SPARTAN MOTORS CHASSIS, INC.

NHTSA # 09V-417

RECALL SERVICE BULLETIN

- SUBJECT:** Optical Warning Devices – Front Turn Signals
- APPLIES TO:** Certain Spartan Motors Chassis, Inc. Firetruck Cab/Chassis produced as Furions having a VDM (Vehicle Date of Manufacture) of August 31, 2006 through October 5, 2009
- CONDITION:** Front Turn Signals do not meet the photometric requirement for FMVSS 108 Standard
- CORRECTION:** Replace Front Turn Signals

FIG. 2-1

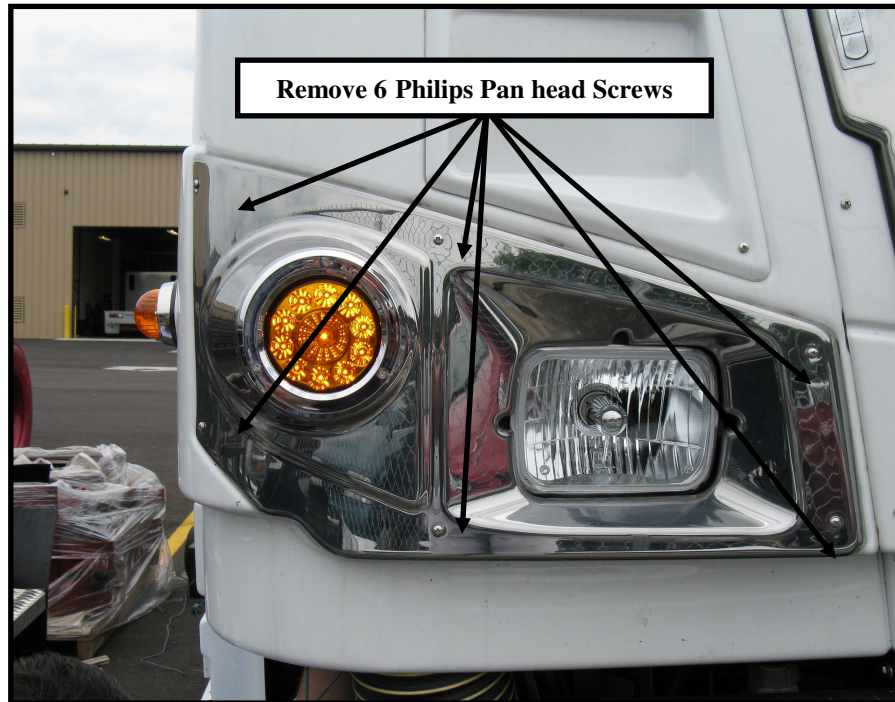
1. Observe all applicable industry safety standards, disconnect any necessary power source, and secure vehicle to allow for installation of front turn signals.
2. Refer to FIG. 2-1. Remove exterior chrome headlamp bezel by removing 6 Philips panhead screws. Retain bezel and screws for reuse.
3. Remove two (2) round chrome exterior trim rings covering rubber grommet by removing 3 Philips-head countersunk screws. Retain exterior trim rings and screws for reuse.
4. Press on backside of turn signal light to remove turn signal from rubber grommets.

5. Disconnect 3-pin weather-pack connector on the pigtail attached to turn signal from cab harness. Properly dispose of turn signal.
6. Re-connect 3-pin weather-pack connector on new turn signal to cab harness.
7. Install new turn signal into rubber grommets by pushing on front of light until it fully seats in rubber grommet.
8. Re-attach two (2) round chrome exterior trim rings onto rubber grommets, reusing 3 Philips-head countersunk screws. Secure as needed.
9. Refer to FIG. 2-1. Re-install exterior chrome headlamp bezels, reusing 6 Philips panhead screws. Secure as needed.
10. Repeat steps for opposite side turn signal.
11. If any power source was disconnected reconnect power source.
12. Test turn signals to ensure they function properly.
